RE: Responses to Request for Additional Information / Control Number 618178

Thank you for your prompt review of our application for a new U.S. Nuclear Regulatory Commission exempt-distribution license for the Prism Optics Module Validation Tool (OMVT). This device has been previously licensed under license 12-24014-01E and license 42-23864-01E. This device has not changed significantly since its initial application in 1998.

## Supporting Data

Picture 1.

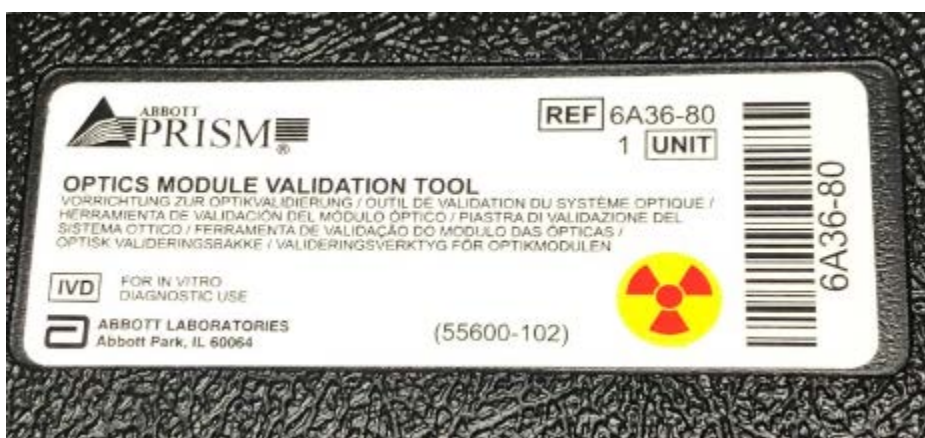
1. **From Nuclear Regulatory Commission:** 10 CFR 32.18(d) requires the applicant to submit copies of prototype labels and brochures, and that the Commission approve such labels and brochures, in order to demonstrate compliance with 10 CFR 32.19(c) and (d). Please provide copies of the labels on the immediate container of check sources, and the accompanying brochure, if any, that may be distributed along with the byproduct material.

**Abbott Laboratories Response:** Picture 1 is of the label on the immediate container of check sources which demonstrates compliance with 10 CFR 32.19(c). Picture 2 is of the plastic case in which the device is stored. Attachment 1 contains the brochure which accompanies each individually packaged device. This brochure demonstrates compliance with 10 CFR 32.19(d).

**Abbott Laboratories Response:** See response to question 1 for a Picture of the labels which demonstrate compliance with 10 CFR 32.19(c). These labels are composed of 2 MIL white polyester with a 1 MIL clear laminate overcoat for durability. They are attached with permanent acrylic adhesive.
